Dear STOL builder:

TOP CHANNEL ZEE REINFORCEMENT

F5-3Z

PART NUMBER: 7F5-3Z

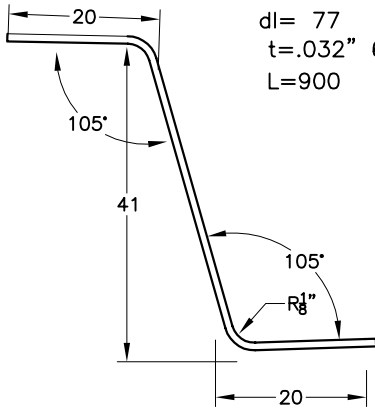
For those of you who may be operating the aircraft in excess of the published VNE and/or at weights higher than the published gross weight figures (you know who you are!), I recommend that the Top Channel be reinforced (see following drawing F5-3Z). Two such aircraft have been reported to have shown signs of buckling along the middle portion of the Top Channel.

While this change is not a required for those of you operating the aircraft in "normal" conditions, I would suggest you inspect the part for any signs of deformations. For those of you using the aircraft in "utility" applications, I suggest reinforcement of the doubler.

dI= 77
t=.032" 6061-T6
L=900

ADDITIONAL REINFORCEMENT Z ANGLE
WHEN 7F5-3 OR 7F5-3SP IS t=.040"
(NOT REQUIRED IF 7F5-3SP IS
t=.063")
